DRAFT FINDINGS OF FACT REQUEST FOR CERTIFICATE OF APPROPRIATENESS FOR ADDITIONS AND ALTERATIONS VILLAGE REVIEW BOARD

PROJECT NAME: 9 Cleaveland Street; Pilgrim House Rooftop Solar

CASE NUMBER: VRB 25-014

REVIEW DATE: June 17, 2025

A-901

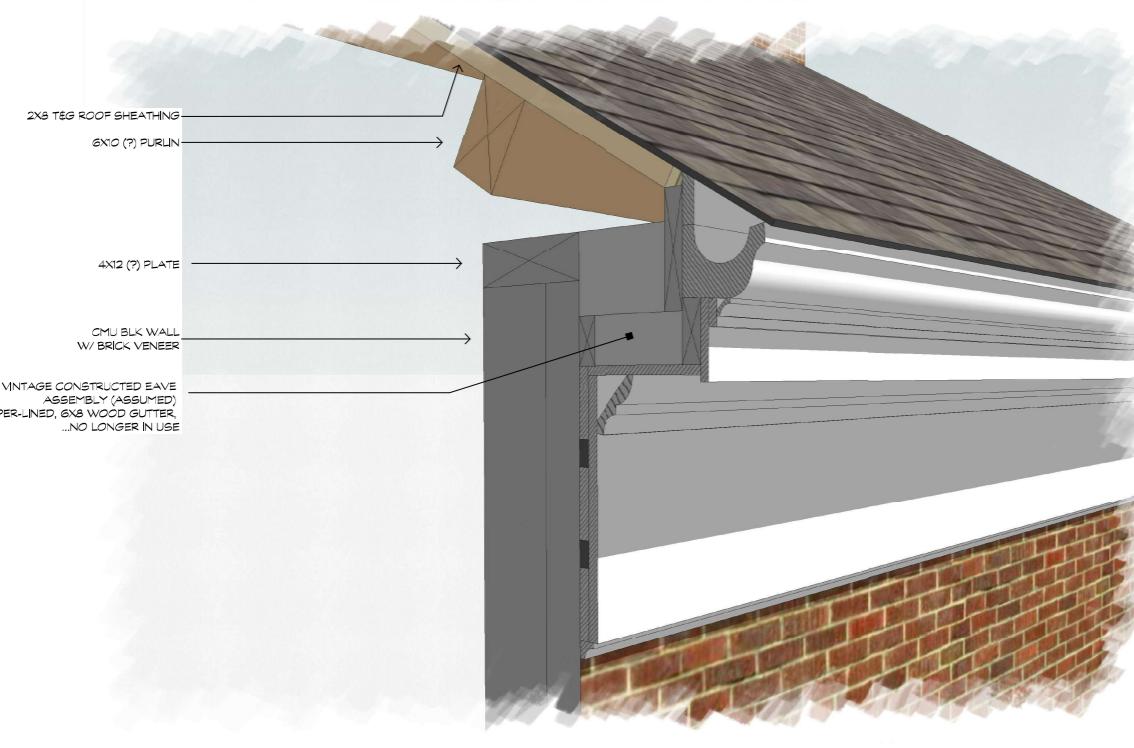
The applicant's proposal to raise the roof slightly will require minimal change to the appearance of the existing fascia. The rooftop solar panels must make use of the southern facing side of the building which also happens to be the most visible roof surface. While the panels will cover the majority (80%) of the south-facing roof, they will be mounted flush to the building. They are also an appendage that is easily removed with no effect on the original structure.
